Response to Examiner's Remarks in Detailed Action

Appl. No. 09/590,586
Response Dated May 7, 2004
Reply to Office Action of 11/10/03

FIGURE 1

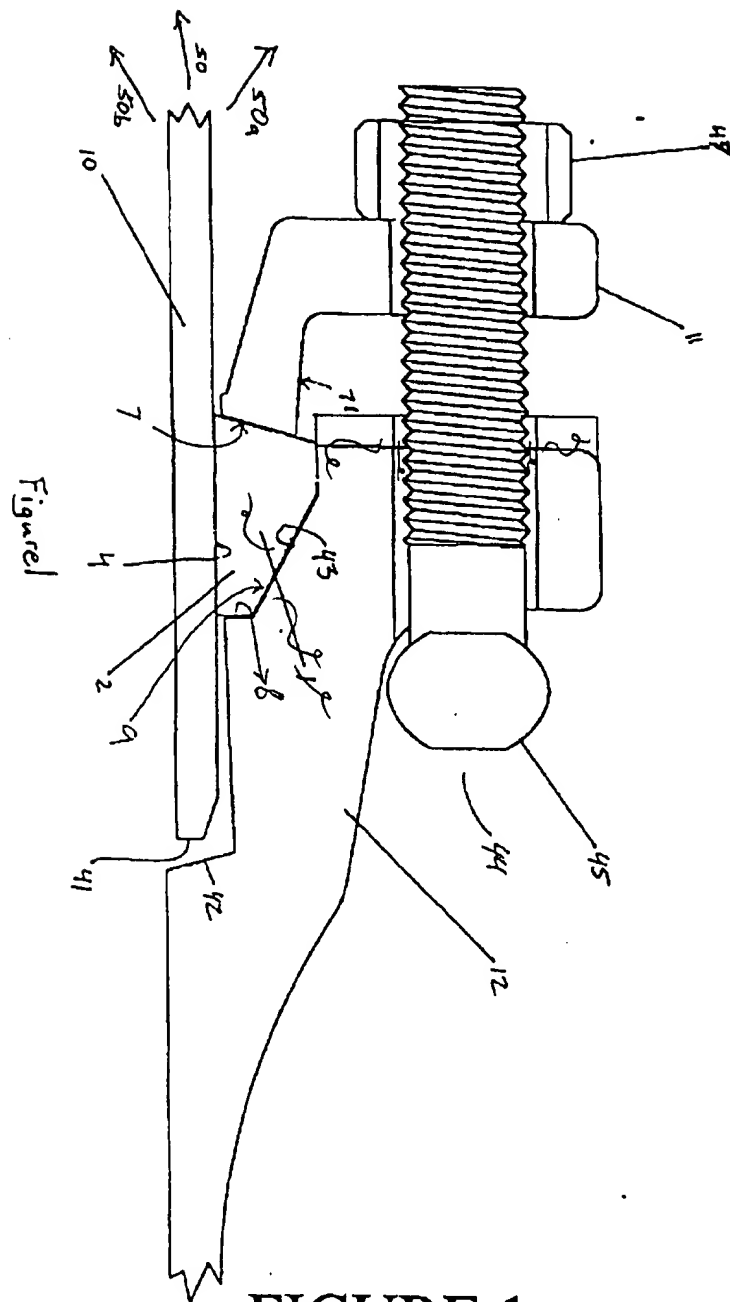
New Claim 17: Applicant adds new claim 17. In contrast to Miller, new claim 17 refers to a single angle between the locking segment and the spigot (as shown in Figures 1 and 4 of Applicant's specification), which faces the extractive direction. Miller, by contrast and as noted by the Examiner, supports its segment both at a leading point and at the rear of the segment, forming multiple angles with the spigot. Additionally, Applicant's claim 17 also recites that the location of contact between the segment and the gland occurs at a location not adjacent the spigot. This limitation is supported by the specification at page 12, lines 3-6

FIGURE 4

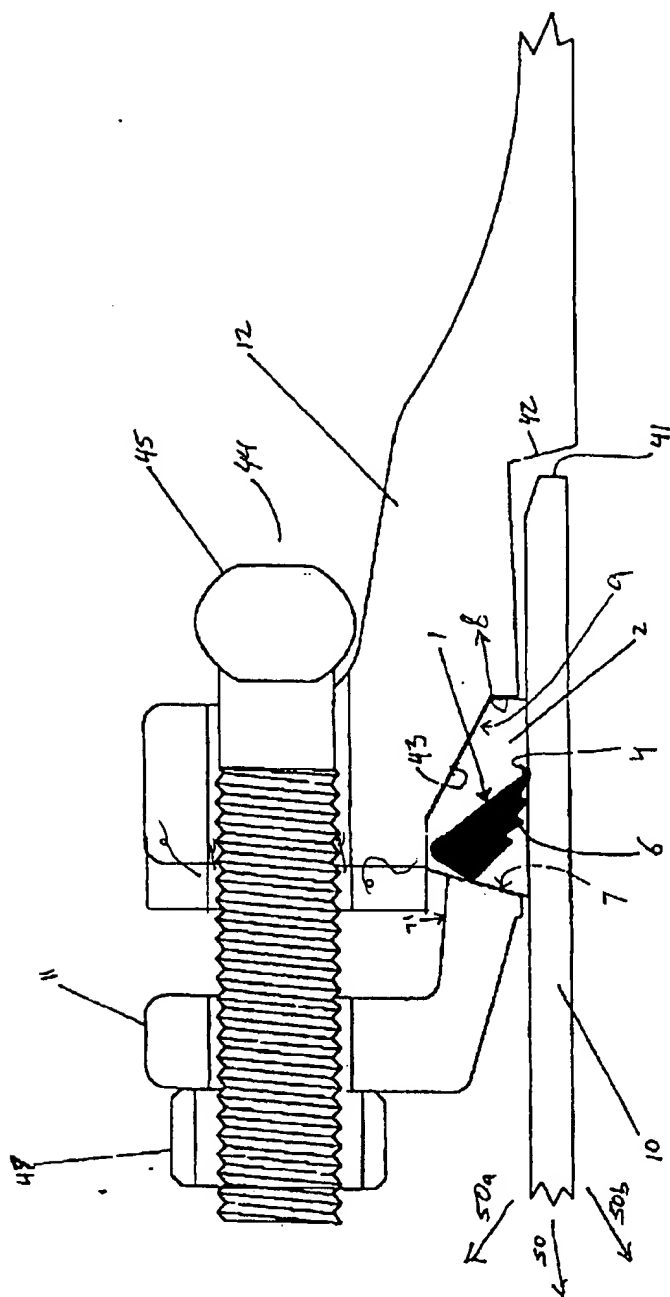
The Applicant's amended claim 3 further recites that the segment bites into the bell (supported at Specification p. 14, line 10; p. 15, lines 1-2, among others), in contrast to the mere contact relied upon by the examiner. Applicant's revised claim also refers to the location of transfer of forces to the bell, which occurs at a bell surface that is substantially parallel to the axis of the bell. This limitation is supported by p. 15, lines 26-28 viewed in connection with Figures 4 and 7 of the application as filed.
